weekly notice

Monday, 9 November 2026

RailSafe

ST PETERS TO ERSKINEVILLE (ILLAWARRA)
 MTMS3A HEADWAY IMPROVEMENTS -
 CHANGING OF ASPECT SEQUENCES AND SPEEDS
 DRIVERS DIAGRAM
 VER 02092026 PAGE 2 of 2

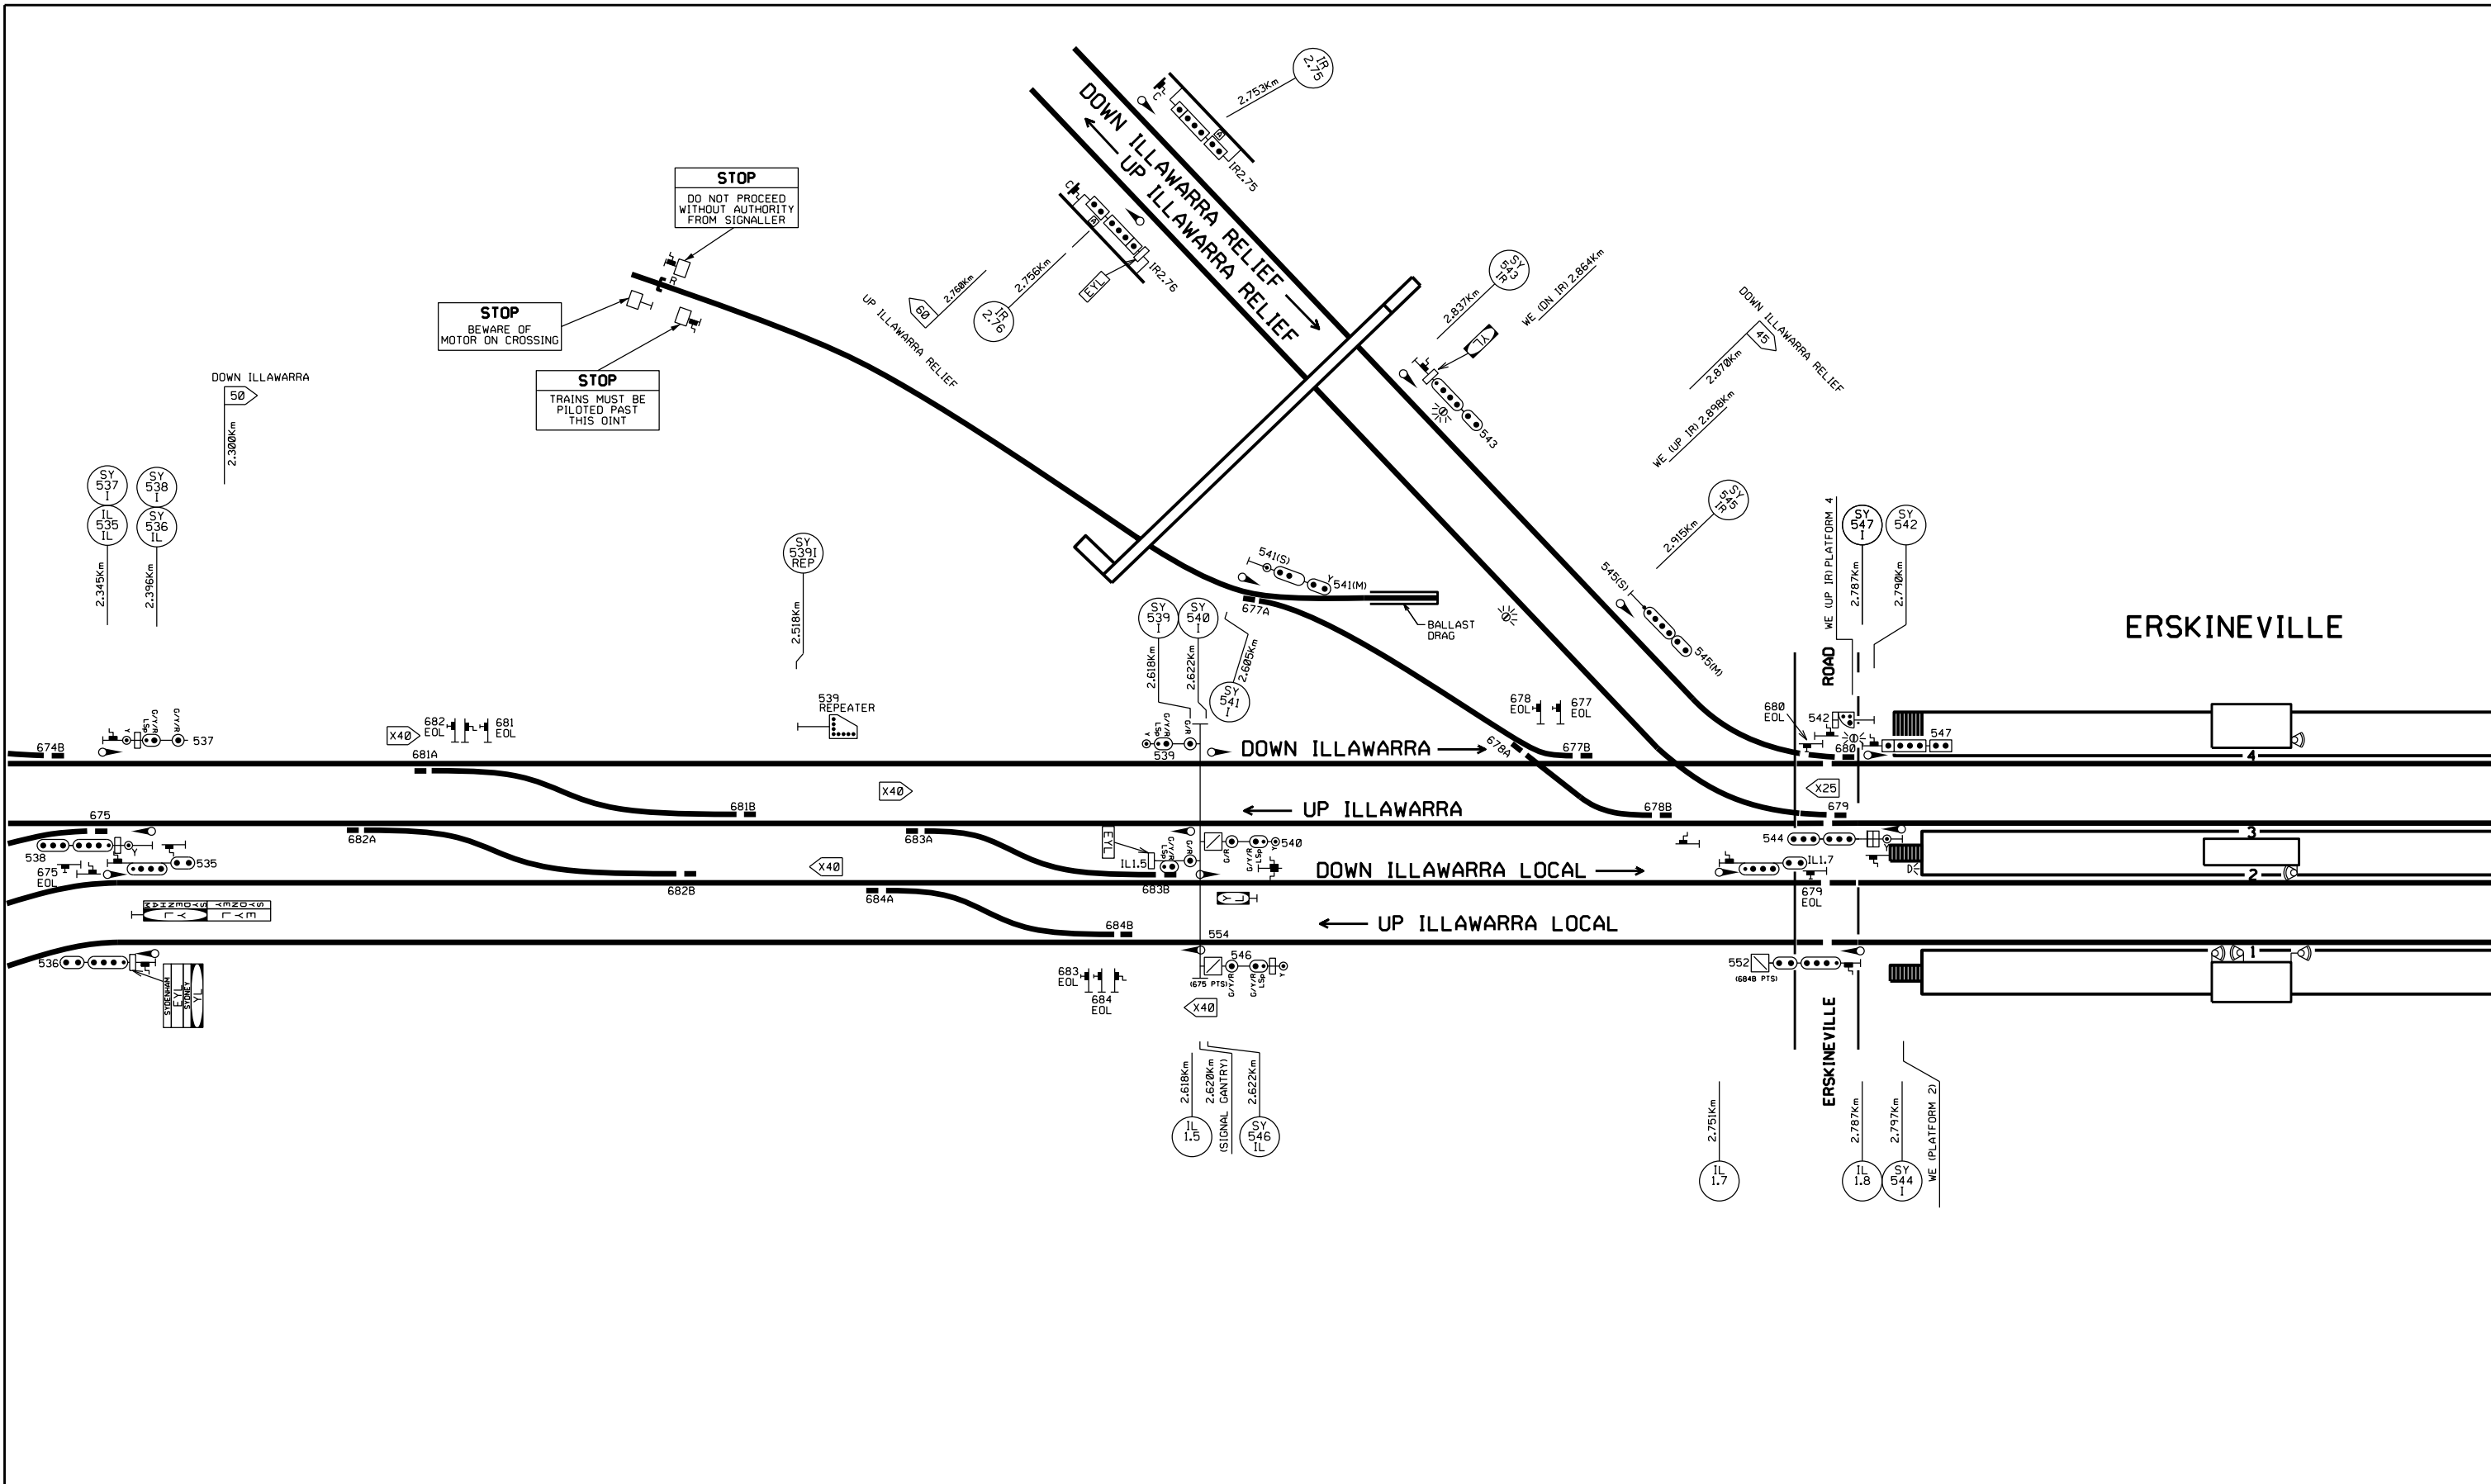
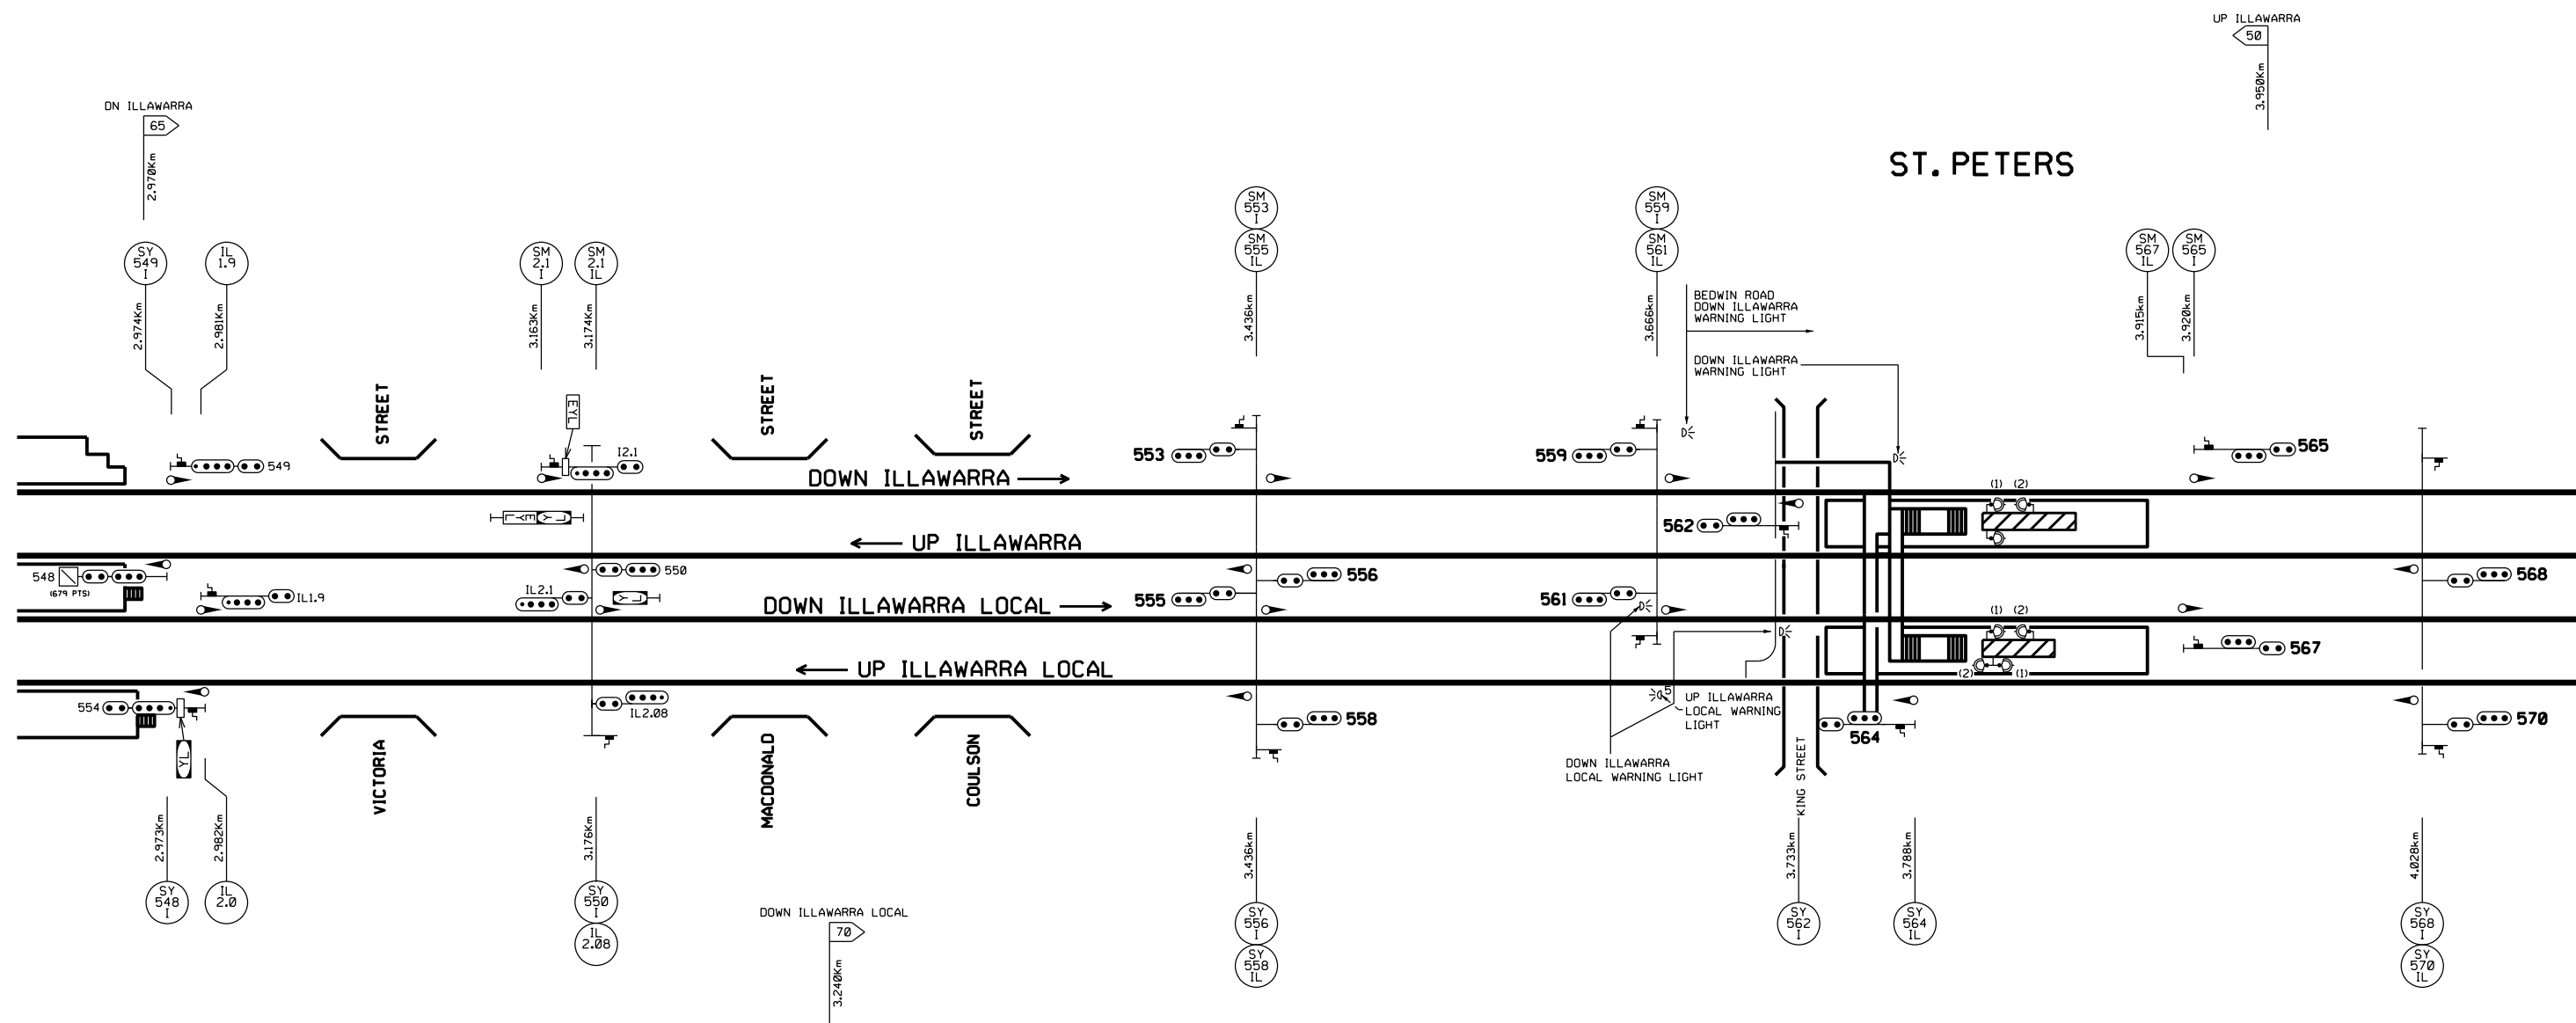
Signal	Modification
SY544I	Removal of Low-Speed aspect, blanking plate fitted.
SY548I	Removal of Low-Speed aspect, blanking plate fitted.
SY550I	Removal of Low-Speed aspect, blanking plate fitted. Removal of Preliminary Medium (Pulsating Yellow) aspect. Removal of Turnout Repeater.

Signal	Modification
SY 541	New Trainstop fitted to this signal.

Speed Sign	Modification
50km/h	Previously installed at 3.950km, tape removed and new speed applies

Speed Sign	Modification
65km/h	Existing sign at 3.265km to be removed
70km/h	Existing sign at 3.950km to be removed

HURSTVILLE
SIGNALLING ARRANGEMENT
NIF SSEW2 HURSTVILLE STAGE 10B (STAGE 1)
MARIYUNG SIGNALLING ENABLING WORKS
Produced by Sigtech Solutions Australia - Signal Design 15102026

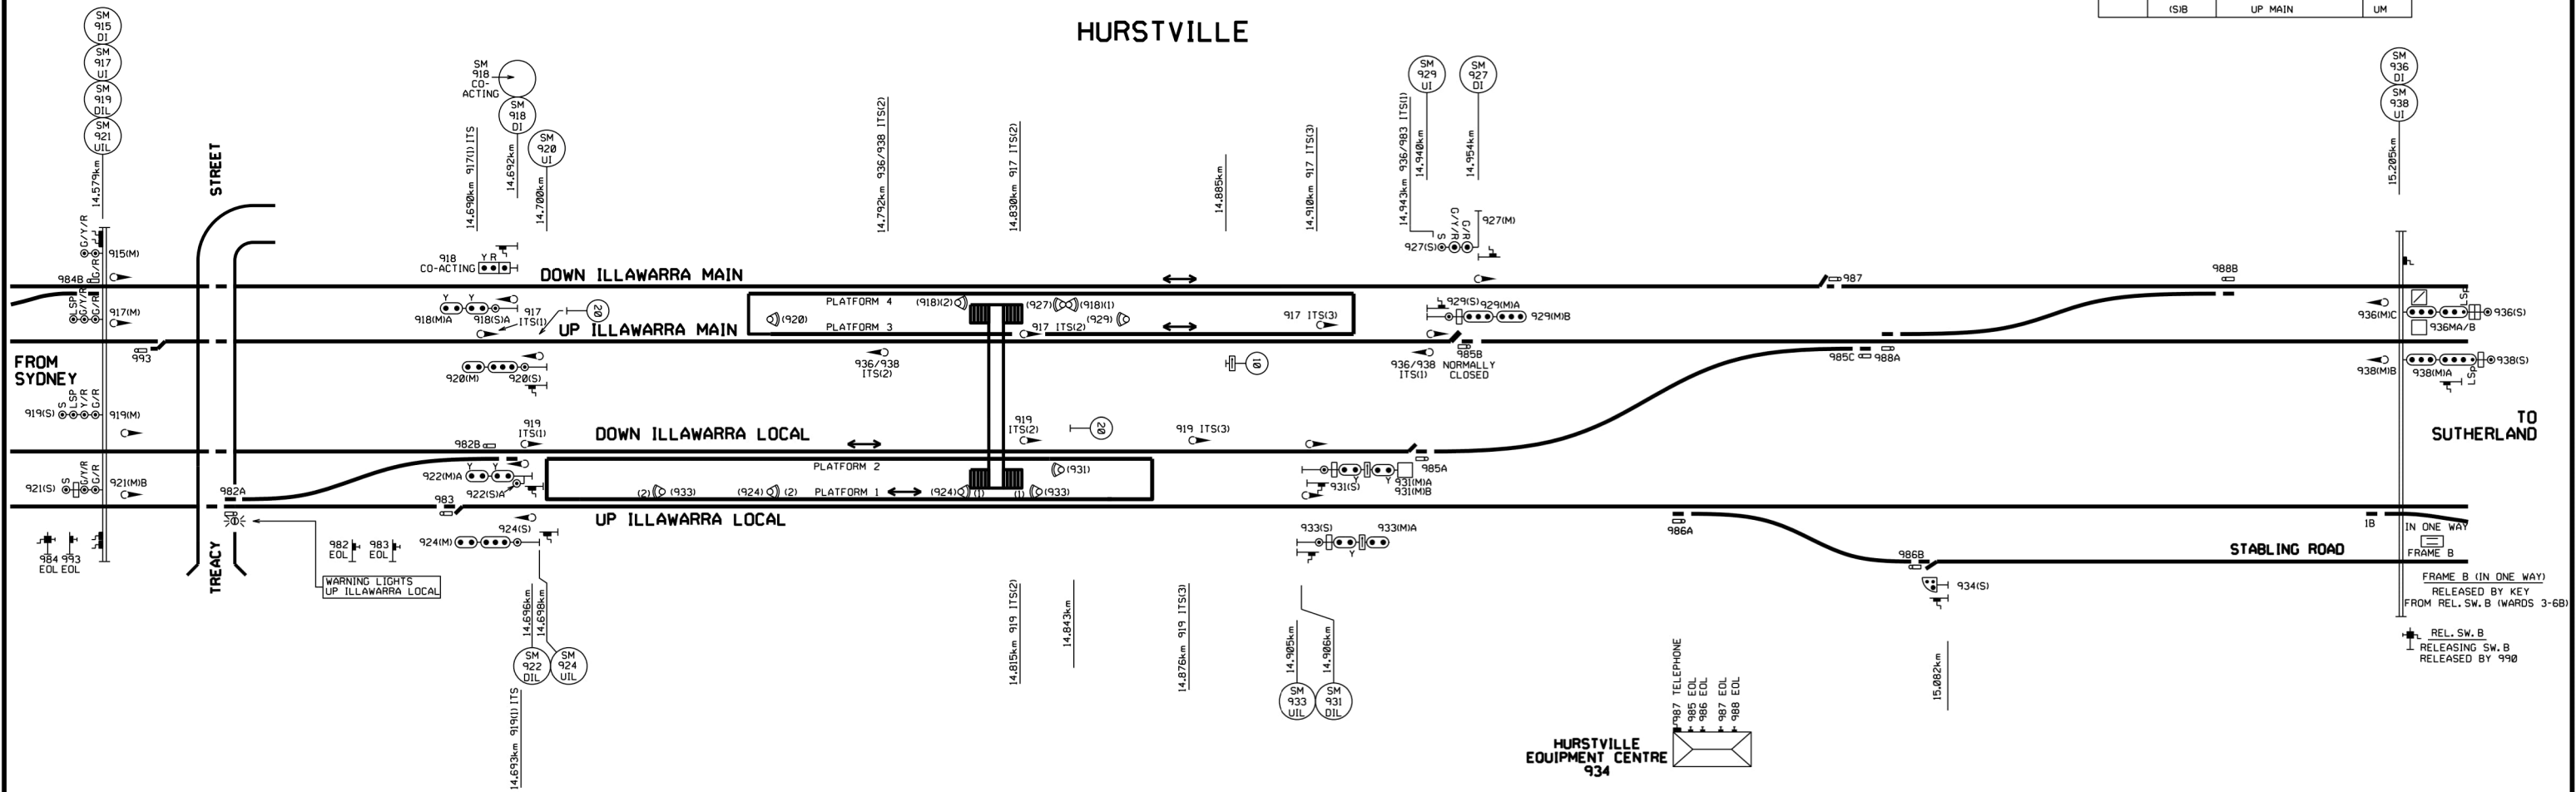
Signal	Location	Modification
SM927DI	Down Illawarra Main, down direction. 14.954 km	New LED/Tri-colour type signal in a gantry cage and associated Trainstop commissioned. Relocated 11m towards country from existing signal.
SM929UI	Up Illawarra Main, down direction. 14.490 km	New pole mounted LED signal and associated Trainstop commissioned. Relocated 3m towards country from existing signal.
SM931DIL	Down Illawarra Local, down direction. 14.906 km	New pole mounted LED signal and associated Trainstop commissioned. Relocated 6m towards country from existing signal, positioned RHS of track.
SM933UIL	Up Illawarra Local, down direction. 14.905 km	New pole mounted LED signal and associated Trainstop commissioned. Relocated 25m towards country from existing signal, positioned RHS of track.

Speed Sign	Location	Modification
55/ 55/ 55	Down Illawarra Local 14.289 km	Black tape removed and sign commissioned. NB: Black taped X45 sign will be commissioned in later stage.
55/ 55/ 65	Down Illawarra Local 14.370 km	Sign removed.
45/ 45/ 45	Up Illawarra Local, Down direction 14.607 km	Black tape removed and sign commissioned
50/ 50/ 50	Up Illawarra Local Down direction 14.607 km	Sign removed.

Item	Location	Modification Information
985B Catchpoint	Platform 3, Up Illawarra Main Down direction	Relocated approx. 5m towards country.
Guard Indicator	Platform 3, Up Illawarra Main Down direction	Additional Guard Indicator installed and will operate in conjunction with Signal SM929UI.
Intermediate Train Stop Speed Sign, 20 km/h	Platform 3, Up Illawarra Main Down direction 14.700 km	Associated with existing mid-platform Intermediate Train Stop (ITS).
Intermediate Train Stop Speed Sign, 10 km/h	Platform 3, Up Illawarra Main Down direction 14.885 km	Associated with new 917 Intermediate Train Stop (3)
